Village of Oxford Planning Commission Agenda
Council Chamber- 22 W. Burdick St., Oxford MI, 48371
Tuesday, October 4, 2022, 7:00 P.M.

Subject: **North Oakland Transportation Authority Parking Lot Expansion – Site Plan Review #1** (*Site Plan dated July 12, 2022*)

Subject: **Clean Hub Car Wash – Site Plan Review #1** (*Site Plan Dated August 29, 2022*)

RE: Engineering Site Plan Review for 153 S. Washington Street, Oxford, MI

1 SITE PHOTOMETRIC PLAN
AS102 1" = 16'

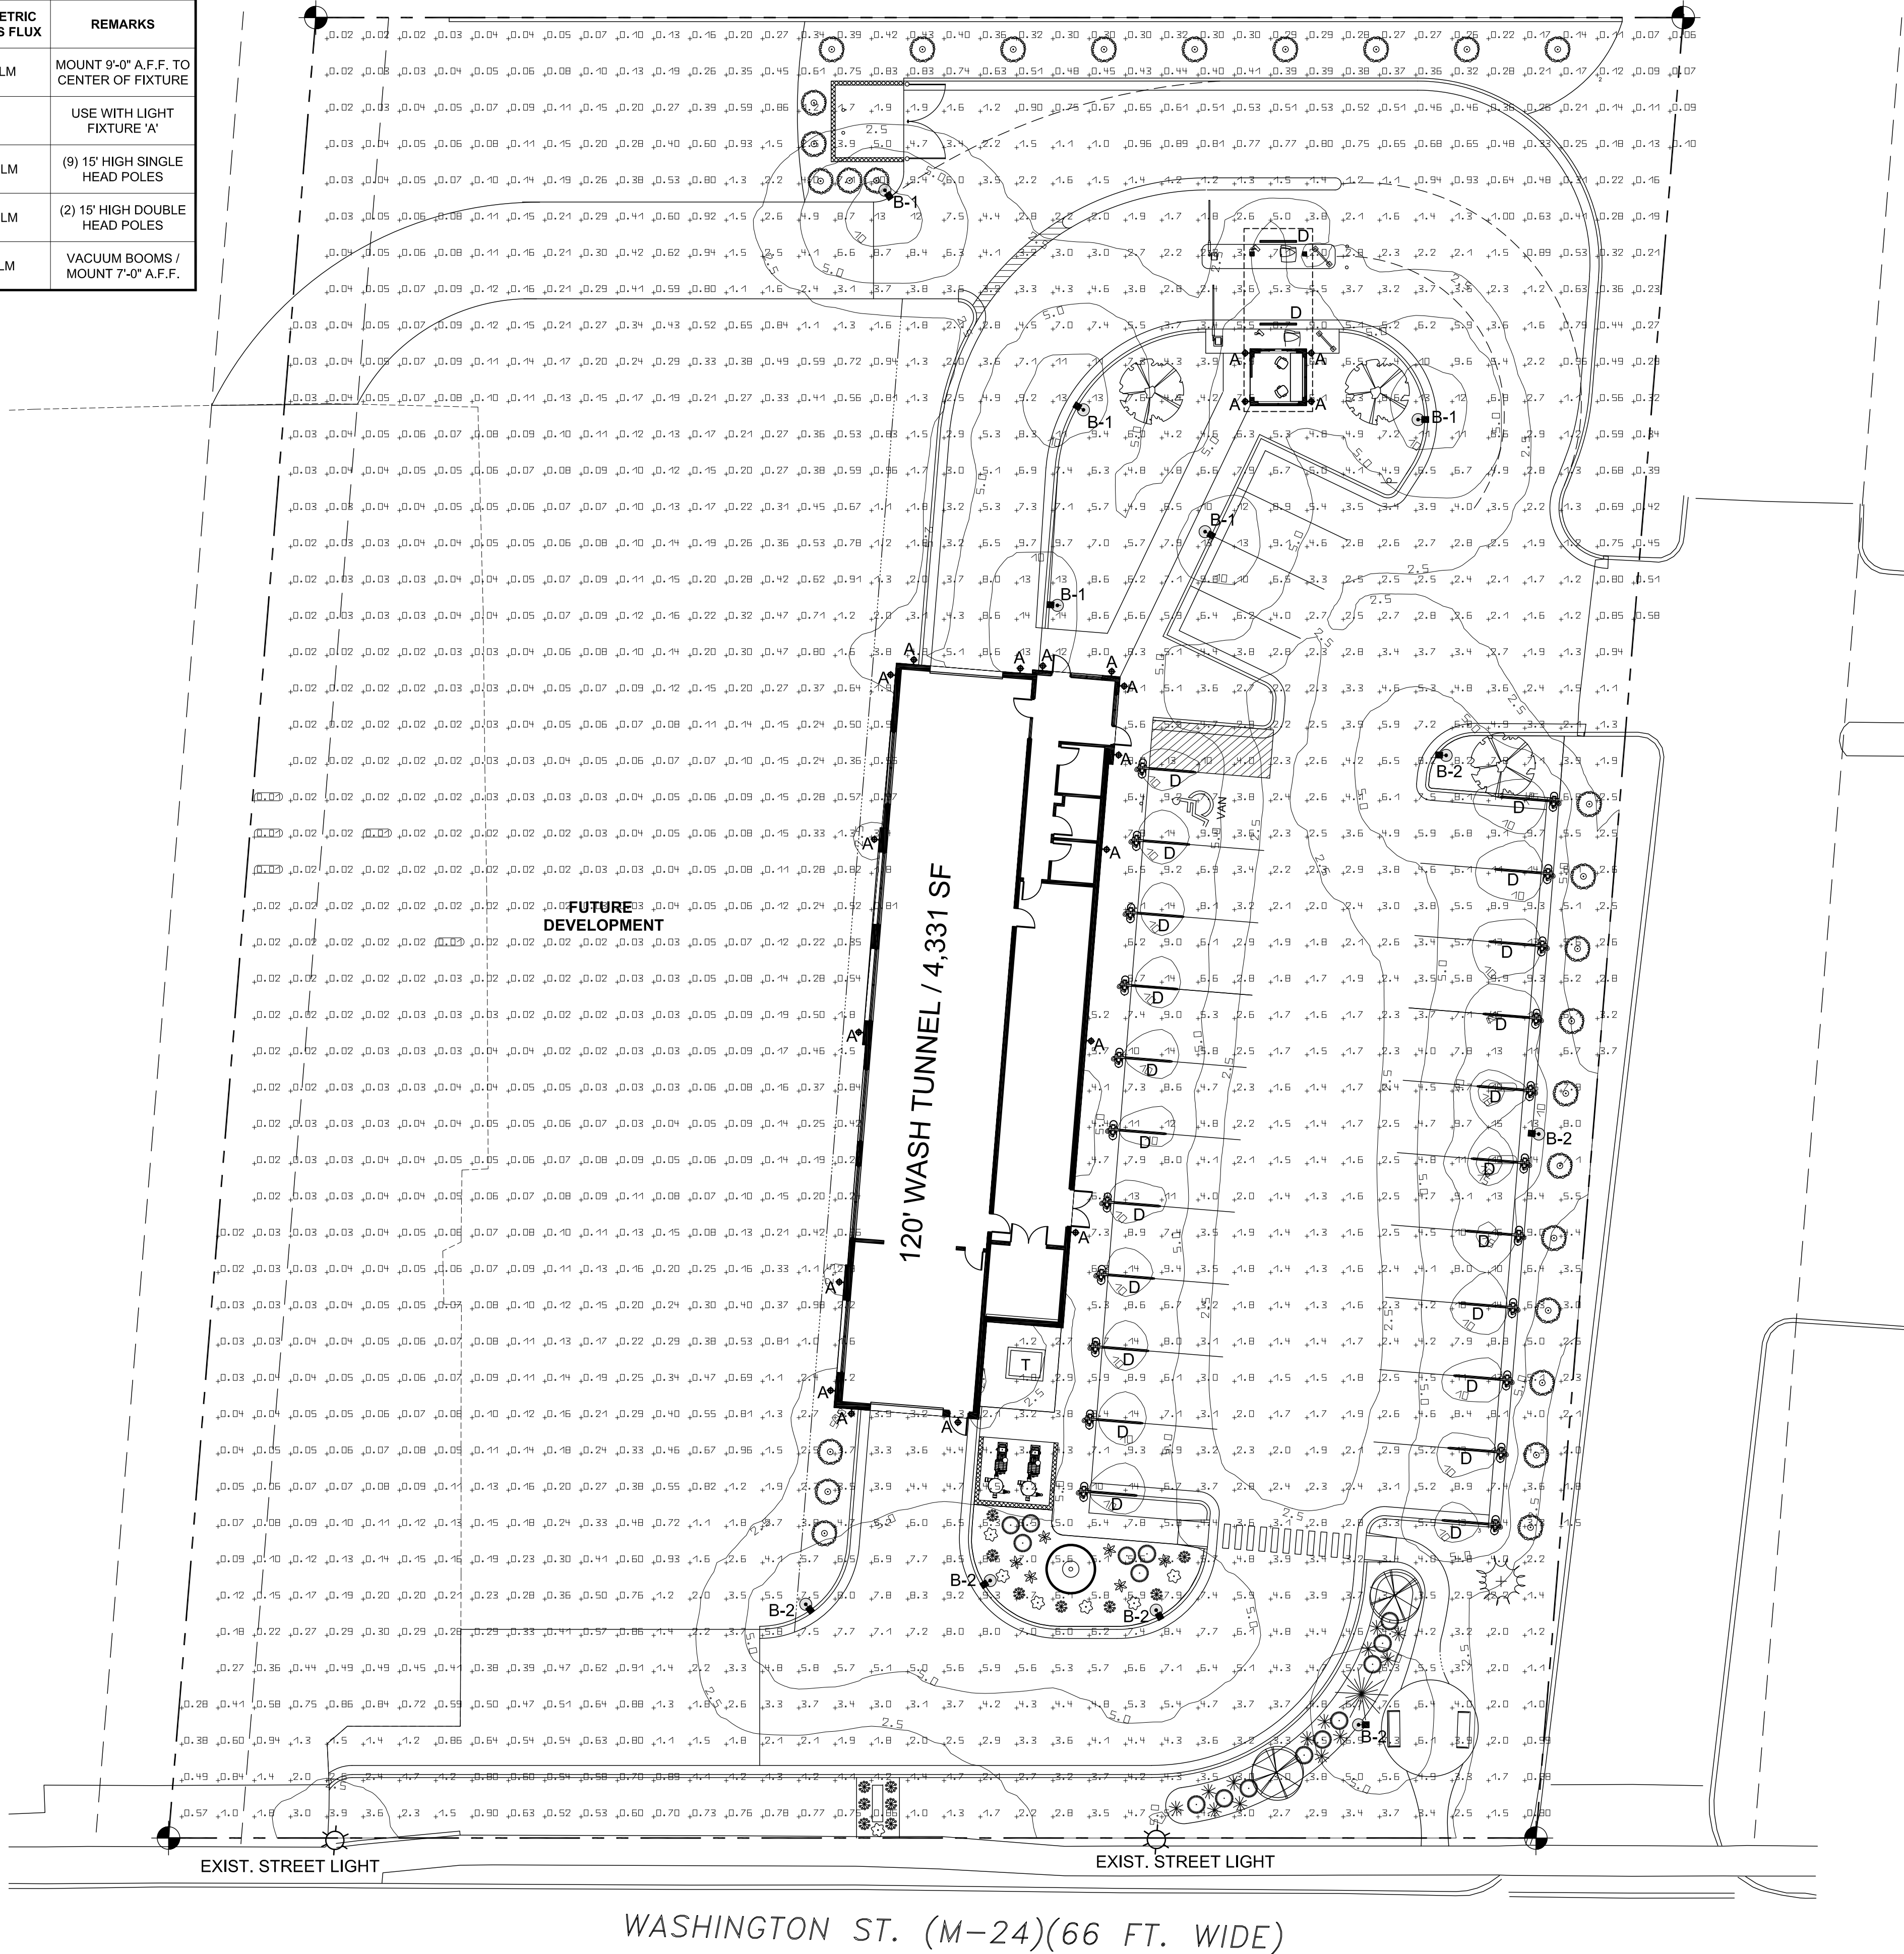
- F. Lighting.** A photometric plan has been provided on Sheet AS102. It includes the location of fixtures along with a lighting schedule that includes mounting height. Detailed cut sheets have also been provided. The following must be addressed:

- 1) Sec. 7.3.2(B) states the maximum light intensity at any right-of-way line shall be one (1) footcandle and that maximum light intensity at any property line other than right-of-way lines shall be 0.5 footcandles. The light levels along S Washington St and the north property line exceed these levels and must be revised to comply with the ordinance.

- 2) Fixture A is described as an up/down wall sconce. The Planning Commission may approve decorative light fixtures as an alternative to shielded fixtures provided they do not cause off-site glare or light pollution. We would suggest the use of fixtures that only direct light downward or the use of a different cylinder lens for the uplight that reduces the lumens projected into the sky.

- 3) The detail sheet for the pole mounted Wareligh fixtures all show using an adjustable mounting brackets. Light fixtures are required to be fully shielded and directed downward. All proposed fixtures must be revised to only utilize a fixed mounting bracket. A note must be added stating all fixtures shall be fully shielded, pointed directly downward, and mounted with fixed brackets to ensure fixtures are not capable of being angled after installation.
